**CITY OF MERCED**  
**Planning & Permitting Division**

**STAFF REPORT:** #16-05

**SUBJECT:** **Conditional Use Permit #1210**, initiated by AL Architecture on behalf of SEW Enterprises, LLC, property owners. This application involves a request to construct a new 2,200-square-foot drive-thru coffee business on an approximately 1-acre parcel, located on the north side of Olive Avenue, approximately 120 feet west of M Street (645 West Olive Avenue). This parcel is located within Planned Development (P-D) #1 and has a Regional/Community Commercial (RC) General Plan designation.  
**\*PUBLIC HEARING\***

**SITE PLAN**  
SCALE: 1"=20'-0"

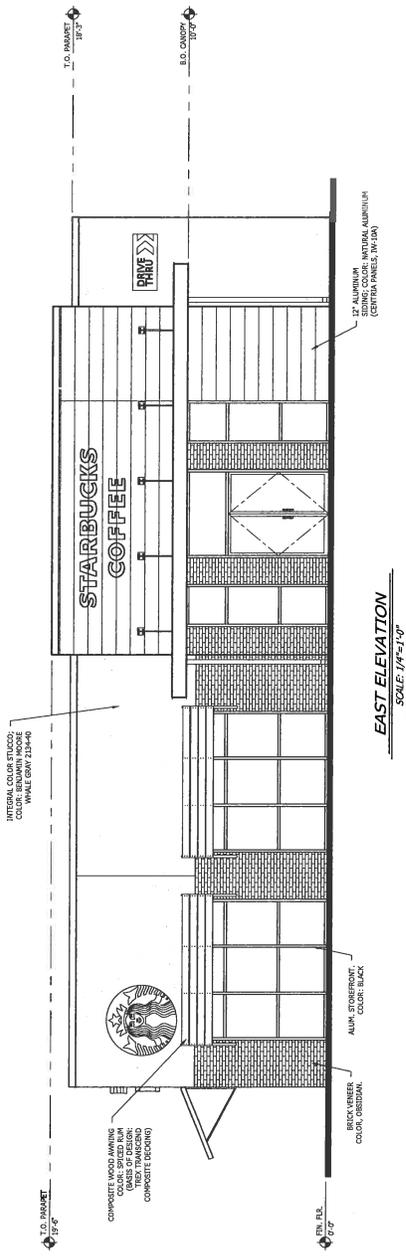
- 26) The "order point" as shown on the site plan (Exhibit 2 – Attachment C of Staff Report #16-05) shall be moved to the west to allow more stacking room in the drive-thru aisle prior to reaching the order point.

The drive-thru entrance is at the northeast corner of the building (Attachments B and C). Vehicles would enter the drive-thru and travel west around the building, pick up their order on the west side of the building, and exit facing south. Once a vehicle has exited the drive-thru lane, it could exit onto Olive Avenue or Fairfield Drive through any of the five available driveways. Because the site is comprised of individual parcels, cross access agreements are required to allow vehicles to travel across all the properties involved (Condition #25). In order to provide more stacking room for vehicles, Condition #26 requires the order point in the drive-thru lane be moved to the west.

26. The "order point" as shown on the site plan (Exhibit 2 – Attachment C of Staff Report #16-05) shall be moved to the west to allow more stacking room in the drive-thru aisle prior to reaching the order point.

# ATTACHMENT E

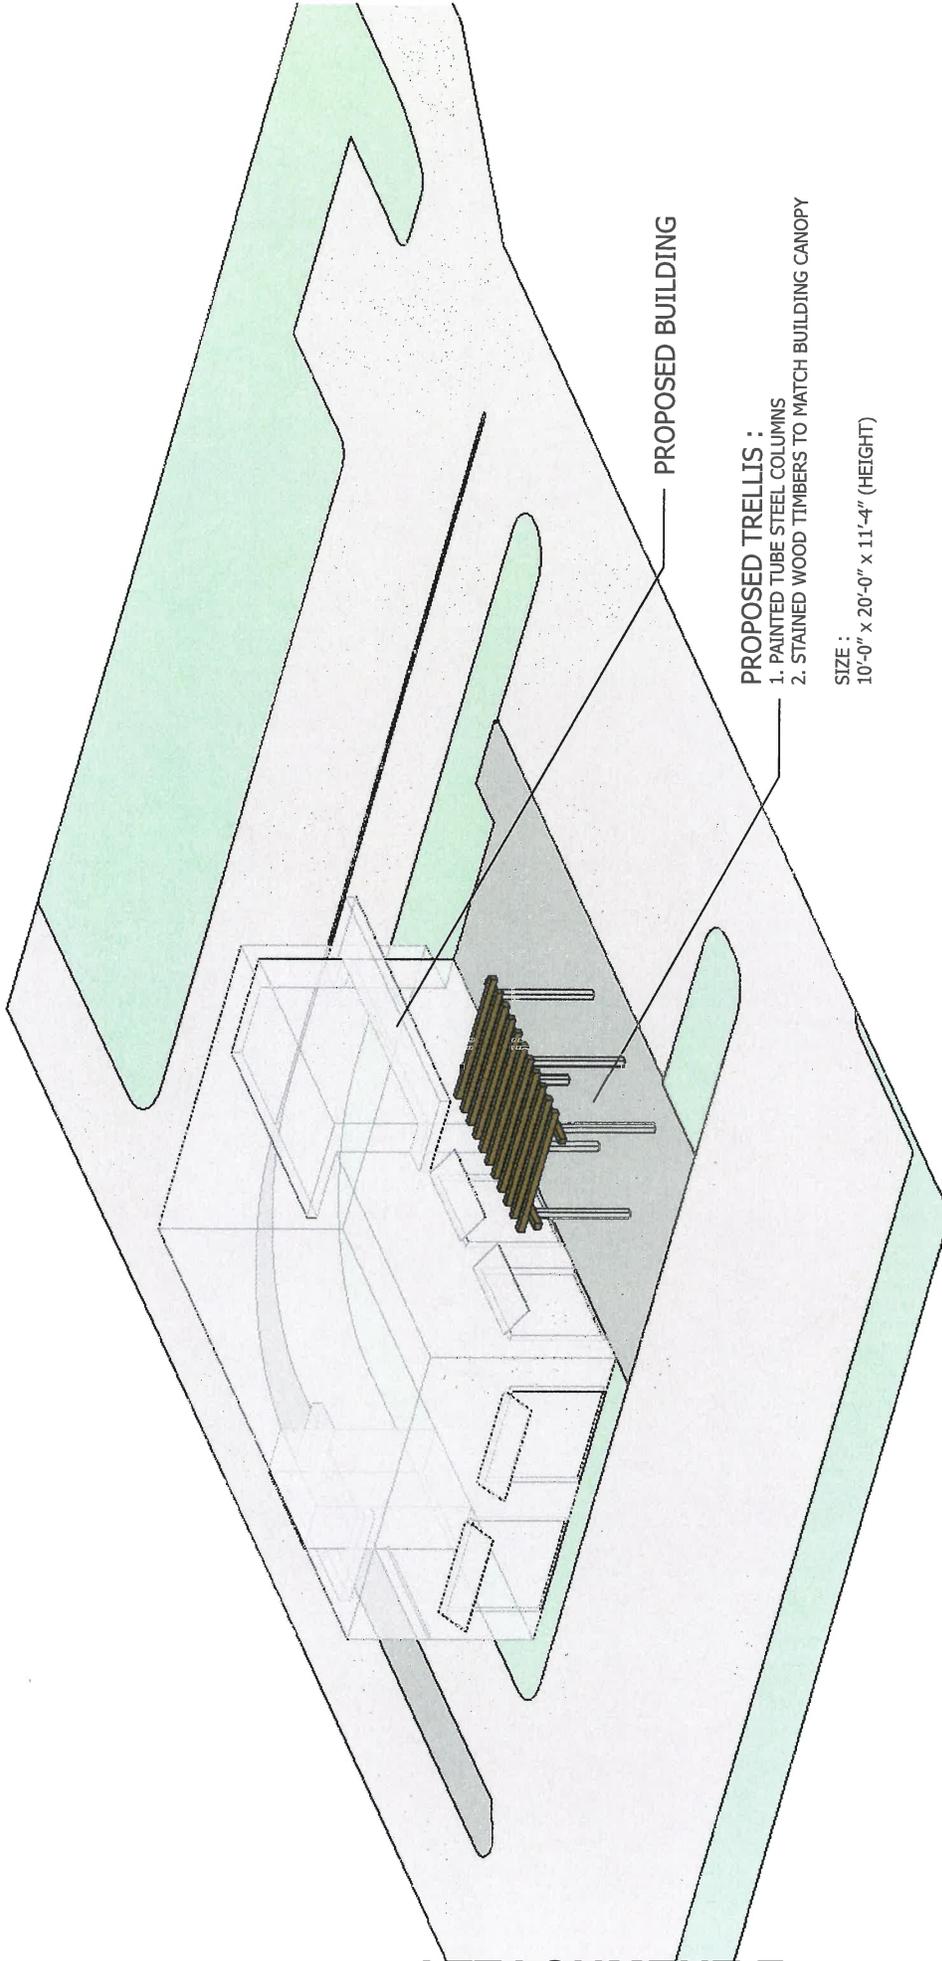
- by approval of an Administrative Conditional Use Permit. No signage (temporary or permanent) shall be allowed on the trellis over the outdoor seating area.

The applicant has not provided a specific sign proposal. Conditions #17 and #18 requires all signing to comply with the North Merced Sign Ordinance. No signing would be allowed on the trellis over the outdoor seating area.

ATTACHMENT F

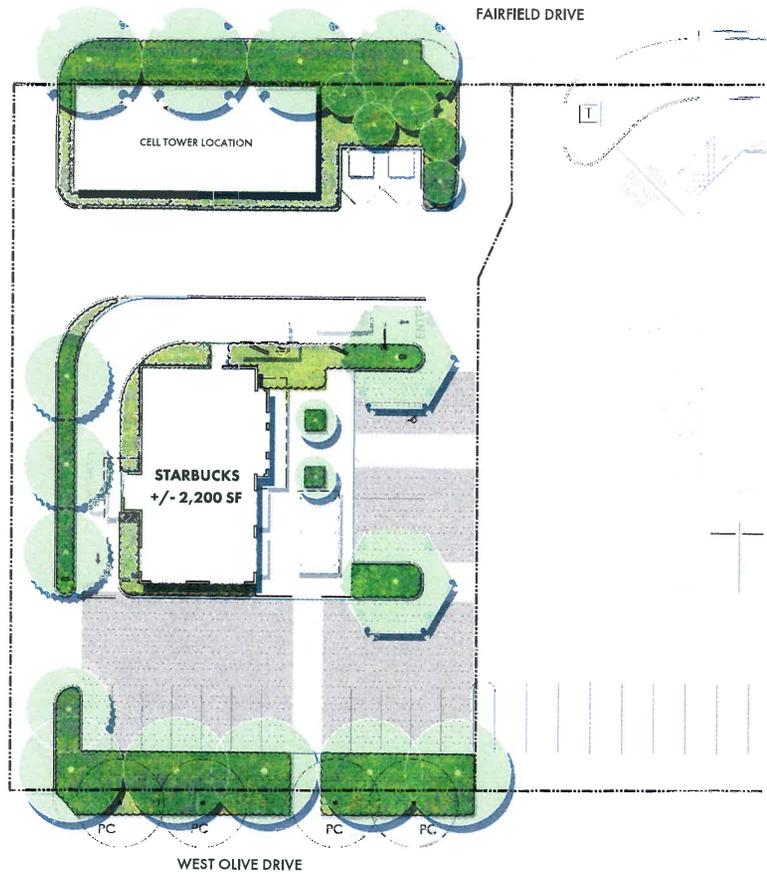
- 27) The developer shall work with the City Engineering Department to design a striping plan to create two right turn lanes from Fairfield Drive onto M Street to help guide traffic into the through lanes rather than into the left turn lane at M Street and Olive Avenue as well as "Keep Clear" or "Do Not Block" markings as shown on Attachment F of Staff Report #16-05.

The overall volume of traffic generated by this use is significantly higher than the existing uses. Therefore, the number of vehicles on Fairfield Drive would likely increase with vehicles both entering and exiting the site. In an effort to alleviate some of this impact, staff has included a condition to require an additional dedicated right-hand turn lane from Fairfield Drive onto M Street be striped and marked and the area on M Street adjacent to the intersection with Fairfield Drive be marked as "Keep Clear" or "Do Not Block" (see the map at Attachment F).

27. The developer shall work with the City Engineering Department to design a striping plan to create two right turn lanes from Fairfield Drive onto M Street to help guide traffic into the through lanes rather than into the left turn lane at M Street and Olive Avenue as well as "Keep Clear" or "Do Not Block" markings as shown on Attachment F of Staff Report #16-05.
